DEPARTMENT REPORT

HEARING 9/9/2025

SUBJECT: FP-2025-0020

Skybreak No. 4 - FP

B. Final Plat (date: 3/1/2025)

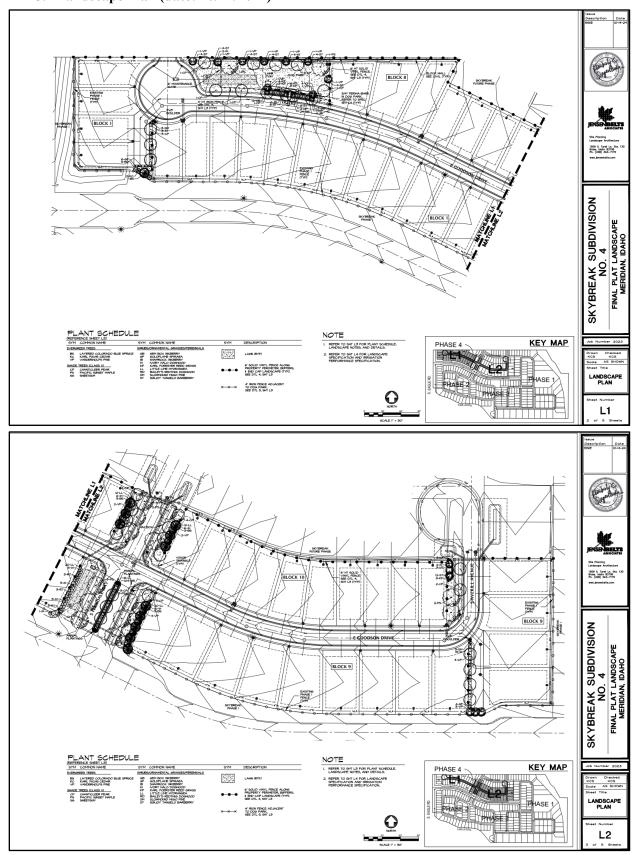
- 2. No building permits shall be submitted until the final plat for the associated phase is recorded.
- 3. The final plat shown in Section VI.G, prepared by Sawtooth Land Surveying, LLC, stamped on 5/12/2025 by James R. Washburn, shall be revised prior to signature on the final plat by the City Engineer, as follows:

- a. Note #14: Include the instrument number for the ACHD sidewalk easement.
 - b. Note #15: Include the instrument number for the City of Meridian sewer and water easement.
